Access Compliance Report

Public Rights-of-Way

(Curb Ramps)

Intersection ID: 31503	Main Street: CHARIDGE_LN	Cross Street: STONEY_PLACE_CT	Location: SE
ADA ID: 9D2245865537	Ramp Type: PerpDiag	Initial Pass/Fail: Fail	Overall Compliance: No
Severity Score: 22.5			
Codes/Mitigation Info/Possible Solution		Field Measurements/Component Compliance

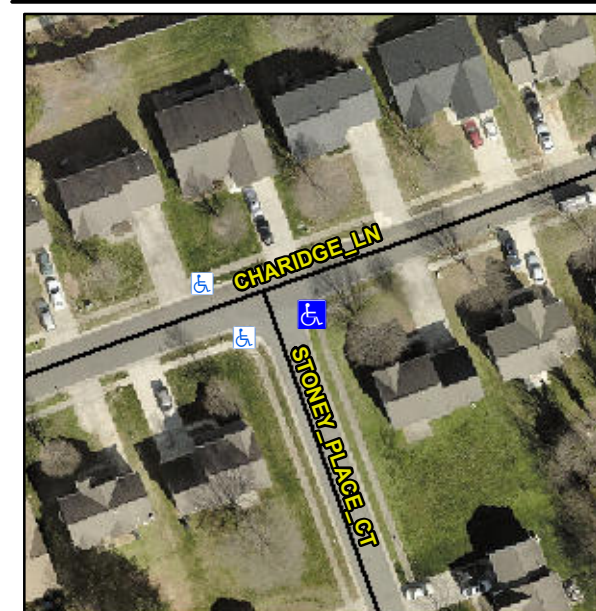
Not Found, R304.5.1, R304.2.2, R304.5.3

Compliance	Description	Data	Compliance	Description	Data
N/A	Ramp Length (in)	46.0	No	Ramp Slope (%)	9.1
No	Ramp Width (in)	36.0	No	Ramp XSlope (%)	3.5
N/A	Flare Type LT	N/A	N/A	Flare Type RT	N/A
N/A	Flare Slope LT (%)	N/A	N/A	Flare Slope RT (%)	N/A
N/A	Flare Traversable LT?	N/A	N/A	Flare Traversable RT?	N/A
N/A	Landing Length (in)	N/A	N/A	DWS Provided?	N/A
N/A	Landing Width (in)	N/A	N/A	DWS Contrast?	N/A
N/A	Landing Slope (%)	N/A	N/A	DWS Length (in)	N/A
N/A	Landing X Slope (%)	N/A	N/A	DWS Full Width?	N/A
N/A	Landing Curb? (Y/N)	N/A	N/A	DWS Offset (in)	N/A
N/A	Shared Landing?	N/A			
N/A	Gutter Ponding?	N/A	N/A	Gutter Slope (%)	N/A
N/A	Gutter Lip Ht (in)	N/A	N/A	Gutter X Slope (%)	N/A
N/A	Painted X Walk1?	No	N/A	Painted X Walk2?	No
	X Walk 1 Direction	To N		X Walk 2 Direction	To W
N/A	X Walk 1 Width (in)	N/A	N/A	X Walk 2 Width (in)	N/A
	X Walk 1 Slope (%)	2.0		X Walk 2 Slope (%)	4.9
	X Walk 1 X Slope (%)	5.5		X Walk 2 X Slope (%)	1.6

Remove & Replace Curb Ramp With Two New Directional Ramps or Equivalent.
